Project	IEEE 802.16 Broadband Wireless Access Working Group < http://ieee802.org/16 >	
Title	Interference Modeling	
Date Submitted	2007-07-09	
Source(s)	Kelvin Au, Steve Yuan, Robert Novak, Sophie Vrzic, Mo-Han Fong Nortel Networks	Voice: +1 613-765-3656 E-mail: Kelvinau@nortel.com Voice: +1 613-763-1395 E-mail: junyu@nortel.com Voice: +1 613-765-8983 E-mail: mhfong@nortel.com * http://standards.ieee.org/faqs/affiliationFAQ.html >
Re:	Call for Comments on Draft 802.16m Evaluation Methodology Document (IEEE 802.16m-07/023)	
Abstract	This contribution provides simulation results for the adequate number of strongest interferers where frequency selective fading and spatial channel should be modeled.	
Purpose	To incorporate the proposed text changes into the Draft 802.16m Evaluation Methodology Document (IEEE C802.16m-06/080r2)	
Notice	<i>This document does not represent the agreed views of the IEEE 802.16 Working Group or any of its subgroups. It represents only the views of the participants listed in the "Source(s)" field above. It is offered as a basis for discussion. It is not binding on the contributor(s), who reserve(s) the right to add, amend or withdraw material contained herein

Figure 1 Spectral Efficiency CDFs

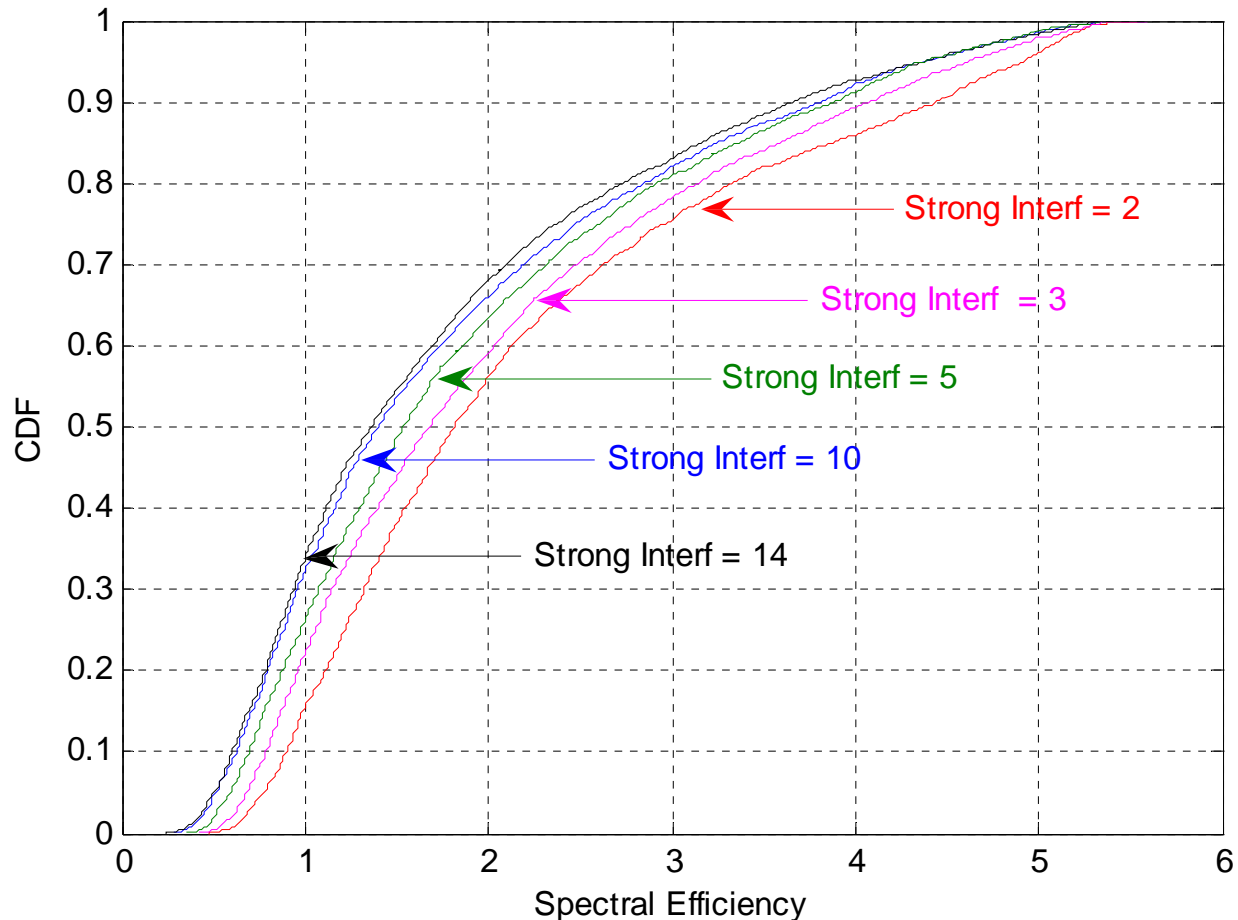
The average spectral efficiency CDF curves for 2, 3, 5, 10, 14 strongest interfering sectors are compared and plotted in Figure 1. As observed, using 10 strongest interfering sectors ($I_{strong} = 10$) should be a good tradeoff between sufficiently modeling the frequency selective fading and effectively reducing computational complexity.

Based on the simulation results shown in Section 2, we propose to model the 10 strongest interferers for frequency selective fading and spatial channel.

[Modify text on page 103, line 13-14 as follows]

... ~~A~~ **For baseline simulation, the typical value for of I_{strong} shall be set to is 14 10.**
